**GOVERNMENT OF THE DISTRICT OF COLUMBIA
DEPARTMENT OF TRANSPORTATION**

MEMORANDUM

SUBJECT: Zoning Commission Case No. 15-02 – 3112 7th Street NE, Brookland Townhomes

Figure 1. Site Plan (Source: Applicant)

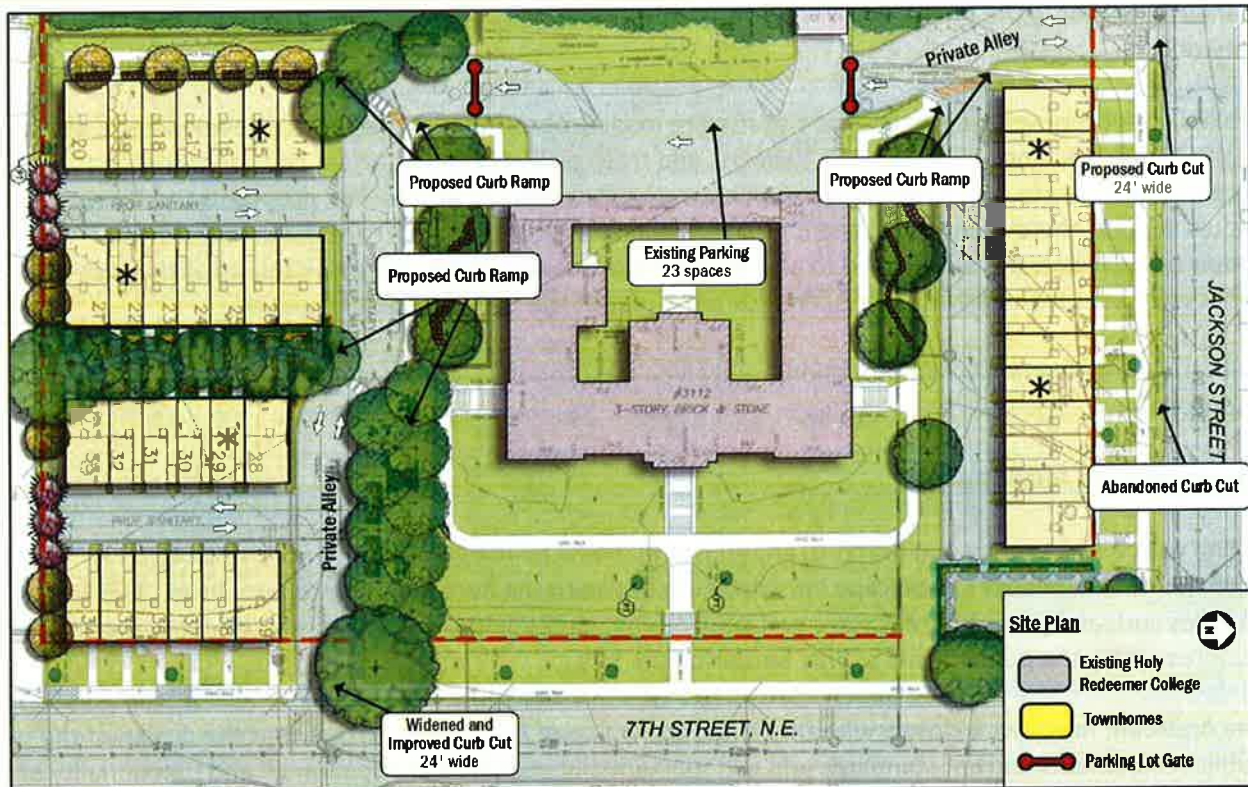
This Site is located at the southwest corner of the intersection of 7th Street NE and Jackson Street NE, encompassing the grounds of the existing Holy Redeemer College. The Site currently contains the existing Redemptorists' Building, which will remain and be renovated for new dwelling units, and 39 new townhomes constructed surrounding the building. Vehicular access will occur via driveways from 7th Street and from Jackson Street. Small private alleys are proposed behind the townhomes providing access to the 48 new vehicular parking spaces. The existing lot behind the Redemptorists' Building with 23 spaces will remain and a one-way southbound access to this lot is proposed. Thus, access to the lot will be from the Jackson Street driveway. Any loading access would also occur via these driveways. The proposed Site access is consistent with DDOT's approach to site access, which seeks alley access and that the number of curb cuts be minimized. Two curb cuts for this project is appropriate.

Primary pedestrian access points are located along each driveway, as well as from the corner of 7th and Jackson. Pedestrians will be able to access any building via the proposed pedestrian network. Bicyclists will access the buildings either via the driveways or sidewalk entrances.

While District zoning requirements do not require loading accommodations for this development, access to this Site for loading and unloading, delivery, and trash pickup is an important consideration. Loading access is expected to occur via the same driveways as for vehicular access. The proposed Site layout should support these operations, and it is expected that all trucks will turn around on the private property. Deliveries are anticipated to also utilize the driveways. Trash will be picked up at the rear of the townhouses in the private alleys, and from the rear of the Redemptorists' Building.

With the onsite loading accommodations, and given the proposed land uses, the loading proposed is appropriate.

- Adhere to the commitments for a TDM plan as proposed in the Applicant's latest filing;
- Provide at least five short-term bicycle parking spaces within public space or distributed within the Site; and
- Provide the required long-term bicycle parking spaces for the Redemptorists' Building prior to occupancy.

- Design of the public realm, including utility vault location and treatment, and bike rack locations; and
- Coordination on the final design for the entrances and pedestrian connections.
